## **REMARKS**

#### Objections to the Drawings

FIG. 5A

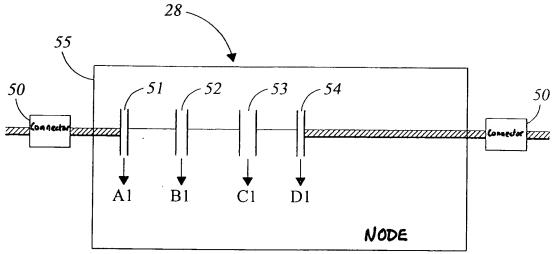
Regarding the objection to Figures, Applicants have amended Figure 1, Figure 2, Figure 5A, Figure 5B and Figure 6 to include descriptive legends for the boxes, as requested by the Examiner, and request that the objection to the drawings be reconsidered and withdrawn.
